April 27, 2022 Allies & Ross Management and Development Corporation IFB#2022-37 -G-E-P-M

New Construction of Northview Midrise

ADDENDUM NO. 2

Attachment A – Project Architect (Fukui Architect, PC) Additions, Deletions and Clarifications to Original Drawings, Dated March 30, 2022

Sheet No. A425 Project #2040

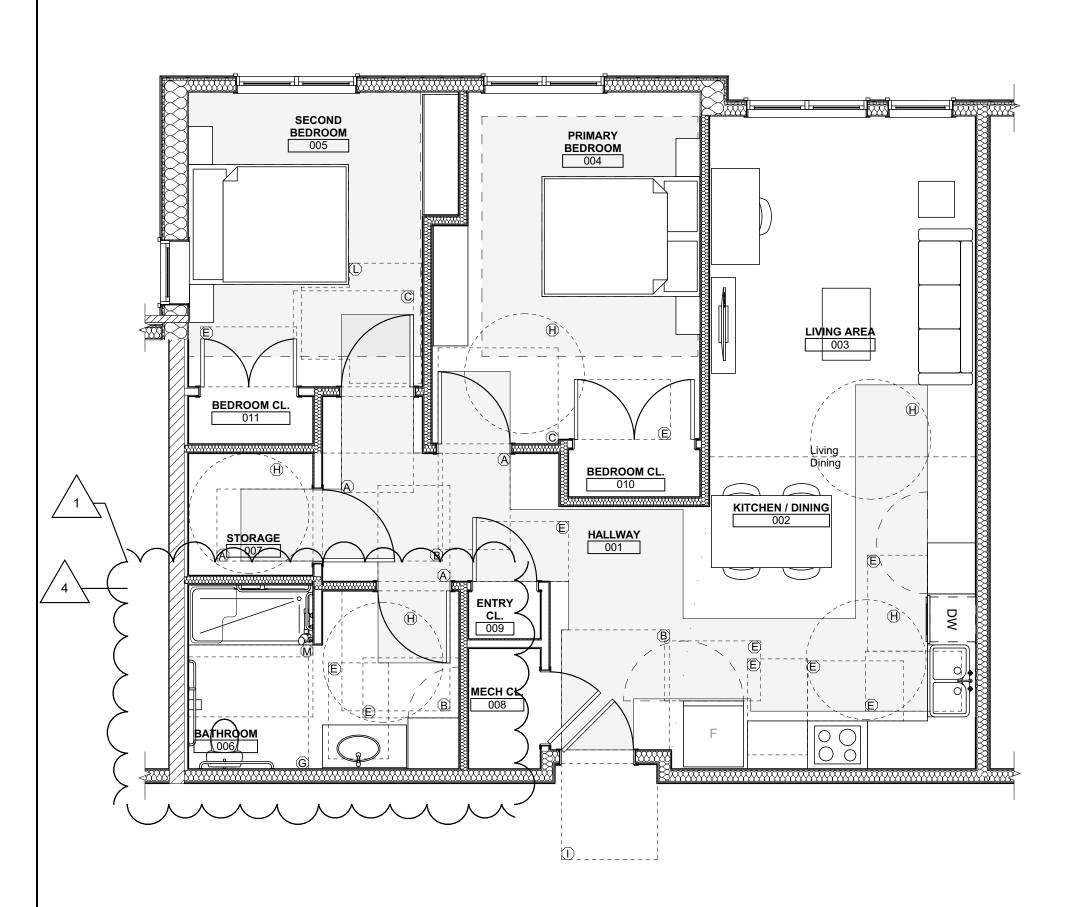
- c) Dwelling Unit Shower and Bathtub Dimensions and Positions for all Grab Bars, Valves, Shower Heads have been revised. Refer to SD1.1.
- **Two Bedroom Type-A Unit Second Bedroom Framing Dimensions** Drawings A416, 4417, A425, A426
